**AMENDMENT NO. 1
to Pine Creek Drainage Basin Planning Study
as approved by City Council 12/18/88, &
as approved by El Paso County
Commissioner 8/25/88
July 17, 1992
Revised July 29, 1992**

Project No. 20-276

July 1992
Amendment No. 1 to Pine Creek
Drainage Basin Planning Study
Approved by City Council 12/18/88,
Approved by El Paso County
Commissioner 8/25/88
Project No. 20-276

FIGURE III
SHEET 3 of 3
JULY 1992

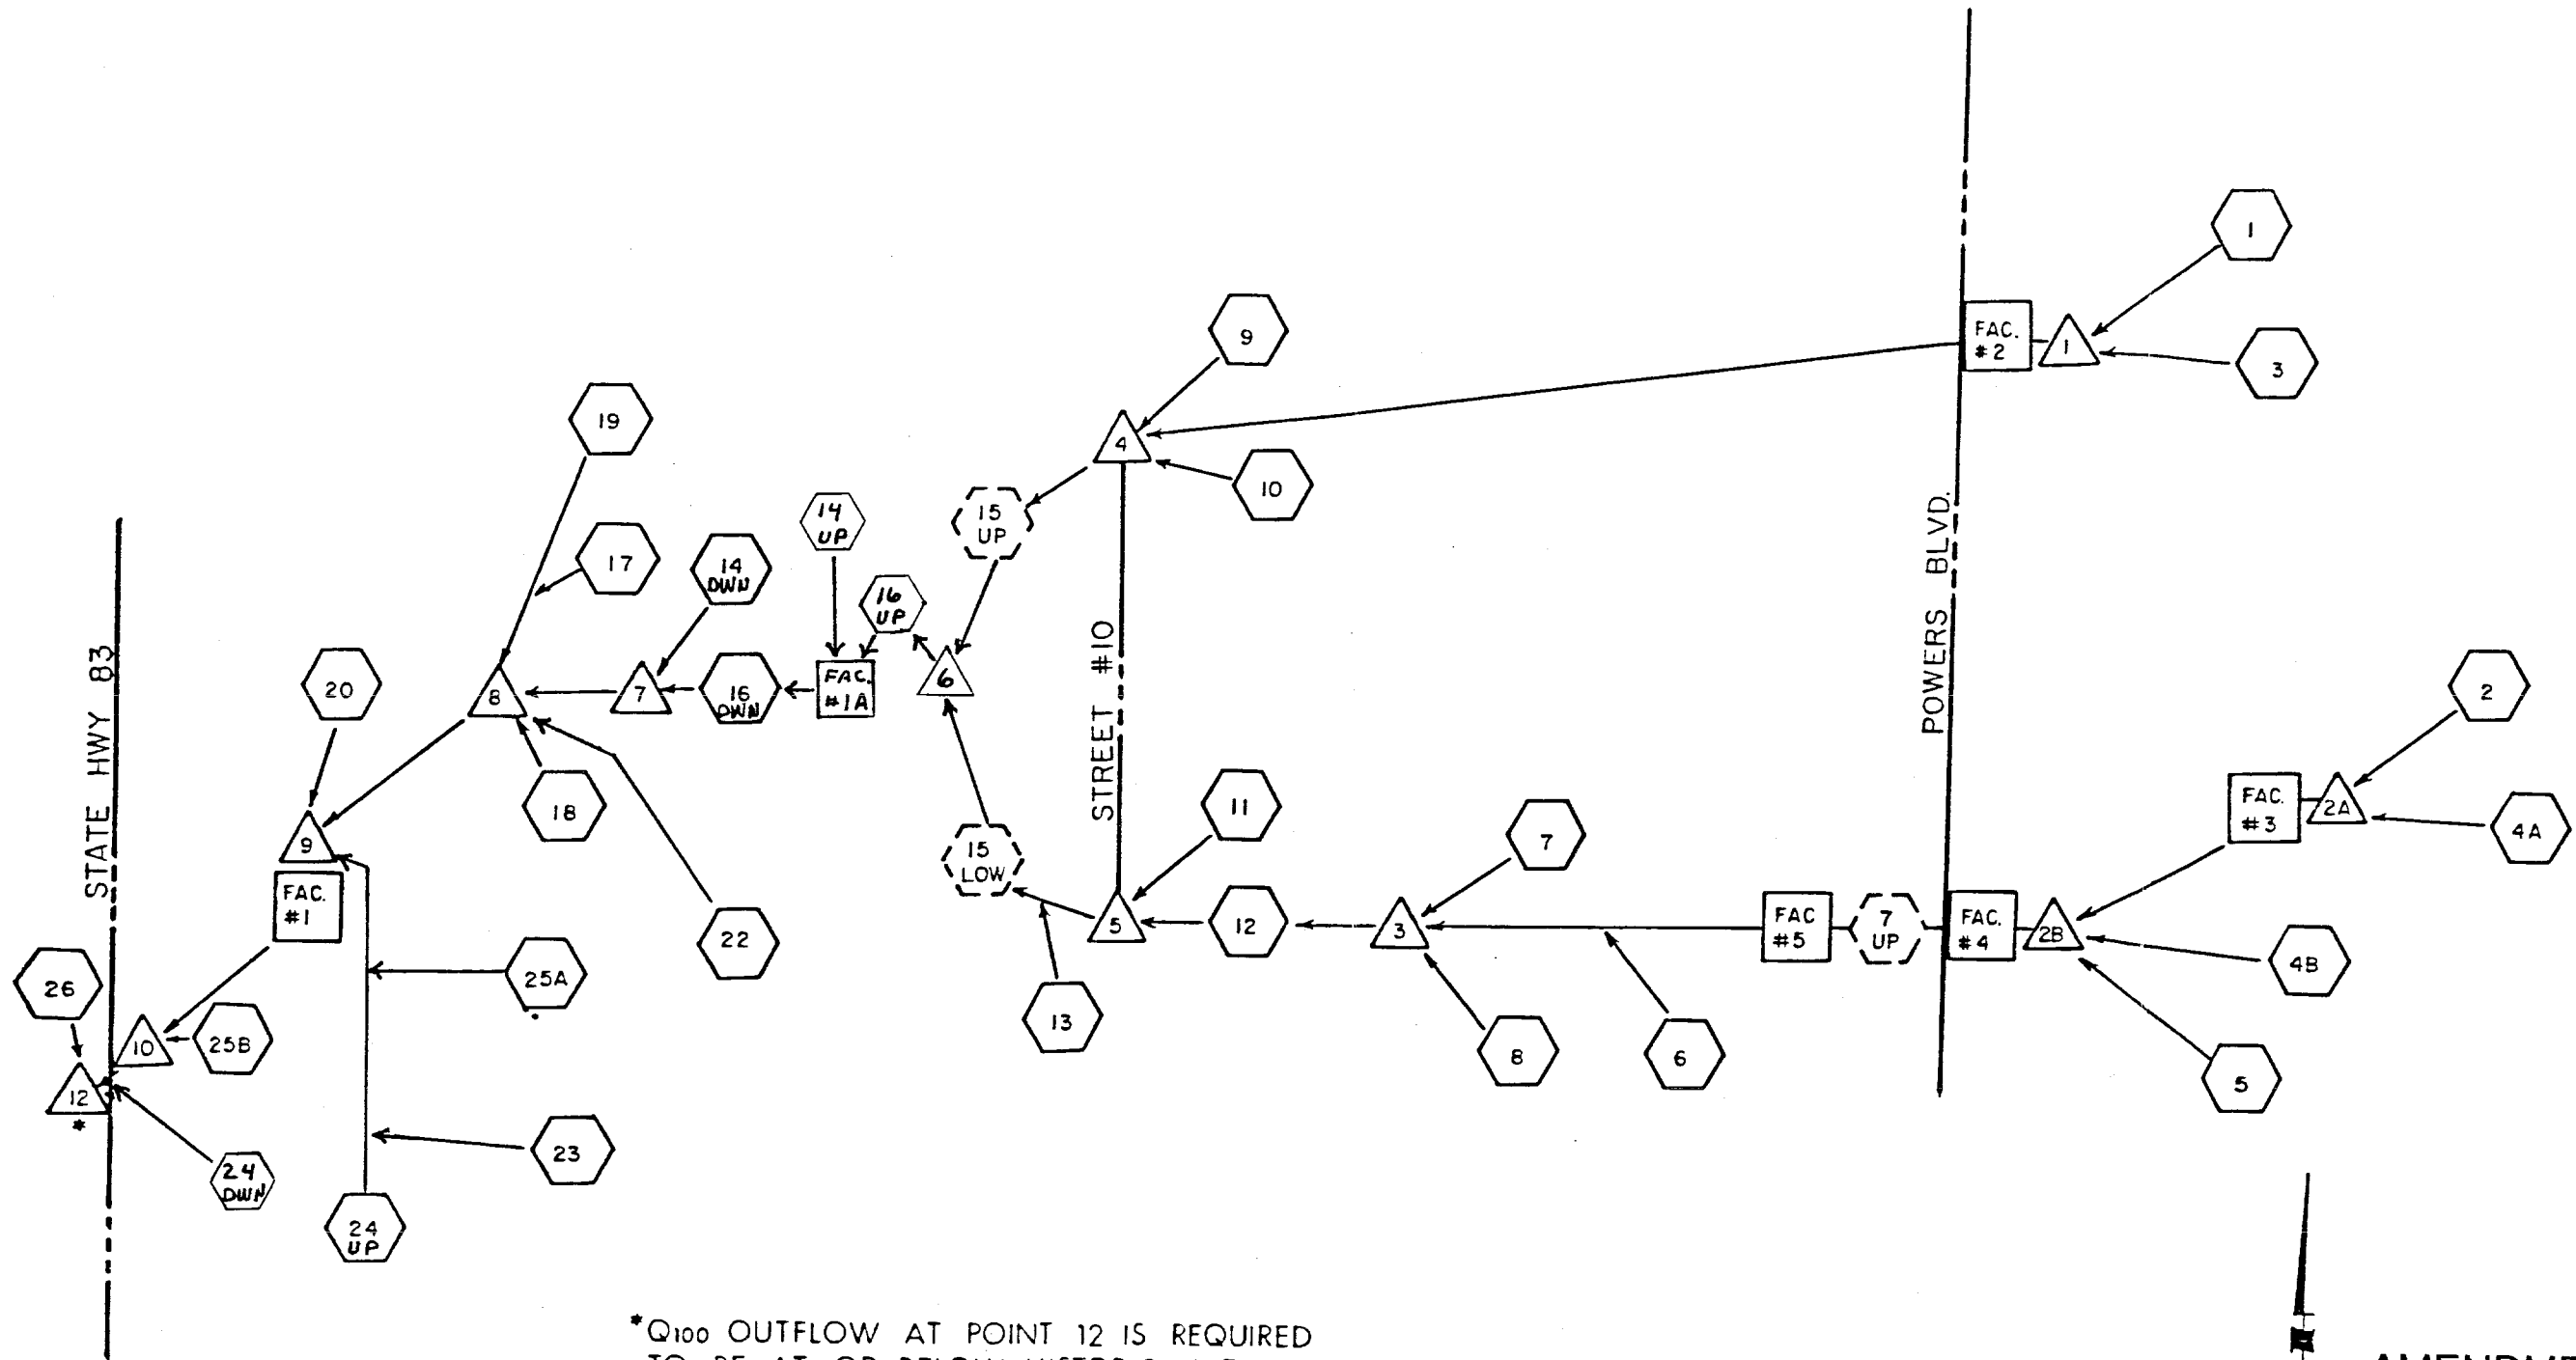
*Changed per Amendment No. 1, July 1992

*Q100 OUTFLOW AT POINT 12 IS REQUIRED TO BE AT OR BELOW HISTORIC UNTIL DOWNSTREAM IMPROVEMENTS ARE IN PLACE. THIS NEEDS TO BE DONE BY TEMPORARY DIVERSION AND/OR DETENTION

PINE CREEK DRAINAGE BASIN MASTER PLAN
BASIN MAP
 7-29-92
 SCALE: 1" = 400'

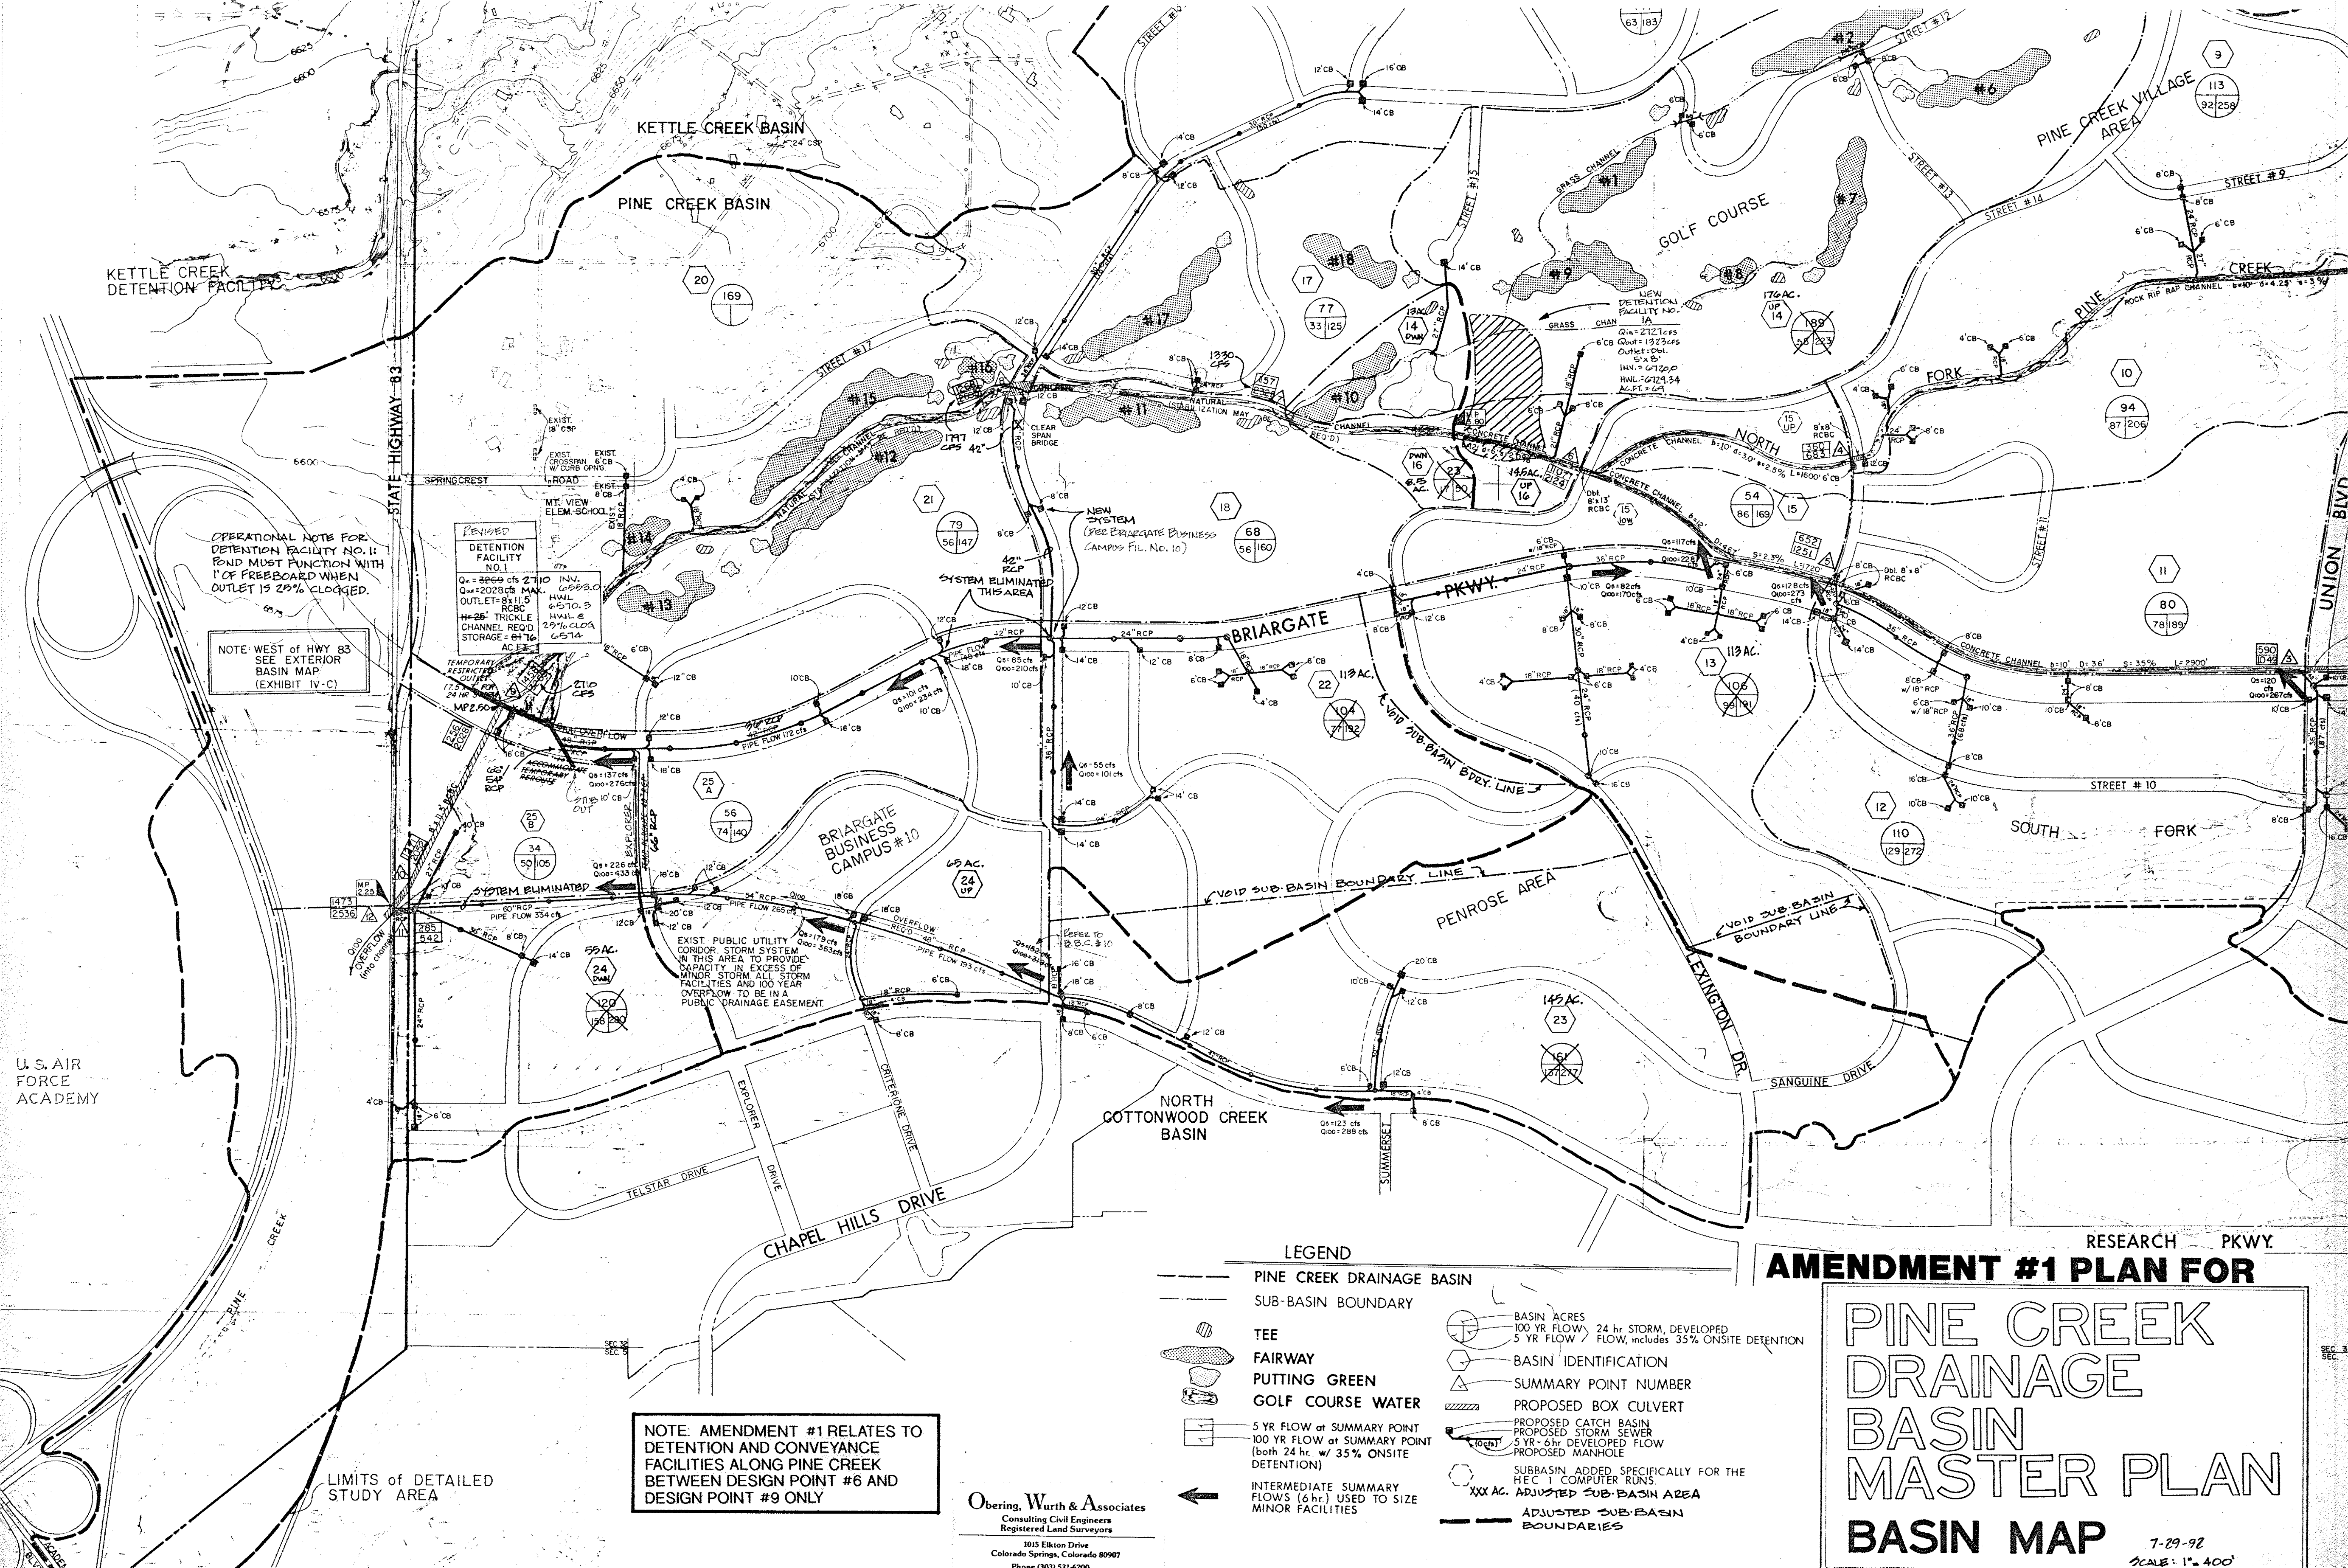
OPERATIONAL NOTE FOR DETENTION FACILITY NO. 1: POND MUST FUNCTION WITH 1' OF FREEBOARD WHEN OUTLET IS 25% CLOGGED.

PROPOSED DETENTION FACILITY NO. 1
 Q₁₀₀ = 2028 cfs 2'10" INV. 6-5-10.3
 Q₅ = 2028 cfs MAX. OUTLET = 8'11.5" RCBC
 H = 26' TRICKLE CHANNEL REQ'D STORAGE = 4876 AC FEET

NOTE: AMENDMENT #1 RELATES TO DETENTION AND CONVEYANCE FACILITIES ALONG PINE CREEK BETWEEN DESIGN POINT #6 AND DESIGN POINT #9 ONLY
